TOSOT Distribution and Installer Partners:

Recently, we have been made aware of certain Lomo+ models making a loud “cracking” noise during and immediately following the defrost cycle. This noise is caused by the expansion and contraction of the indoor coil where it attaches to the plastic case. To mitigate this noise, please do the following:

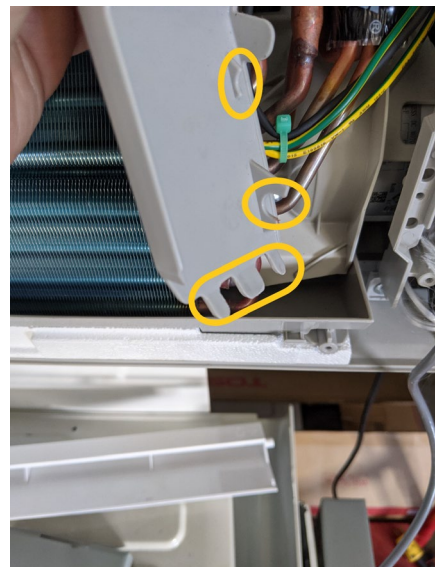
- 1.) Remove the front case assembly from the rear case
 - a. Remove louver
 - b. Remove screws beneath louver
 - c. Remove screws beneath filter cover
 - d. Pop out latches across the top rear
- 2.) Locate coil mounting screws on the left side of the coil (highlighted in yellow) and remove, lift up and reposition the coil, then reinstall the screws loosely (4 turns from tight).

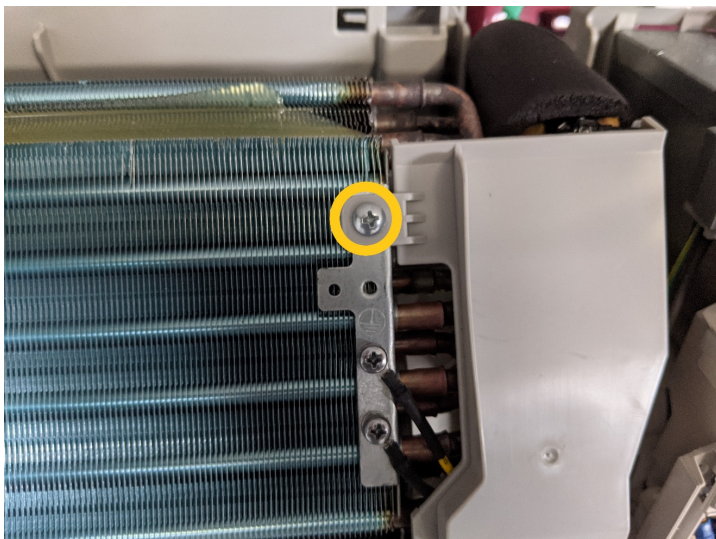
- 3.) Remove the gray plastic condensate drain shield from the right side of the coil
- 4.) Place one layer of electrical tape on the highlighted sections

- 5.) Locate the coil mounting screw on the right side of the coil, in front of the motor housing (highlighted in yellow). Remove and reinstall loosely (4 turns from tight.)

- 6.) Reinstall the condensate drain shield with the screw slightly loose.
- 7.) Reinstall front case assembly
- a. Clip into top rear clips
 - b. Install screws beneath filters
 - c. Install screws beneath louver compartment
 - d. Install louver
- 8.) Run unit to verify noise is reduced.

Performing the above steps allows the indoor coil to flex without causing as much stress on the plastic case, resulting in lower noise levels.
